AS104 NOTES:
CEILING & BULKHEADS REVISIONS WITH AS104 REVISIONS NOT CLOUDED

METRIC SCALE DRAWING
FIRST FLOOR ELEV. +93.60m

SQ ALEXANDRA PARK - BLOCK 11
38 CAMERON ST., TORONTO, ONTARIO M5T 2H2

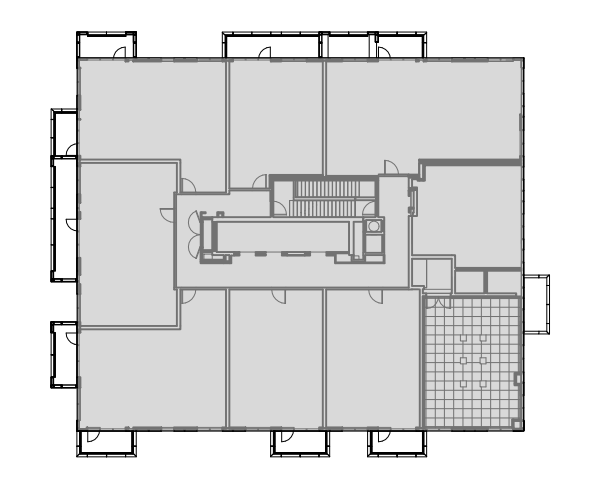
SUITES PH05 AND PH11:
ACOUSTIC CEILING C3 AT ±2750 THROUGHOUT SUITE. ROUTE R/W/ AND/OR CEILING DUCTS AND SPRINKLERS IN TYP. BULKHEADS AT ±2450 BELOW ACOUSTIC CEILING.

ALL OTHER PH SUITES:
INSULATED CEILING C1 AT ±2750 THROUGHOUT SUITE. ROUTE SPRINKLERS AND DUCTS IN TYP. BULKHEADS AT ±2450. INSULATE BULKHEADS - DO NOT EXTEND C1 CEILING ABOVE BULKHEADS.
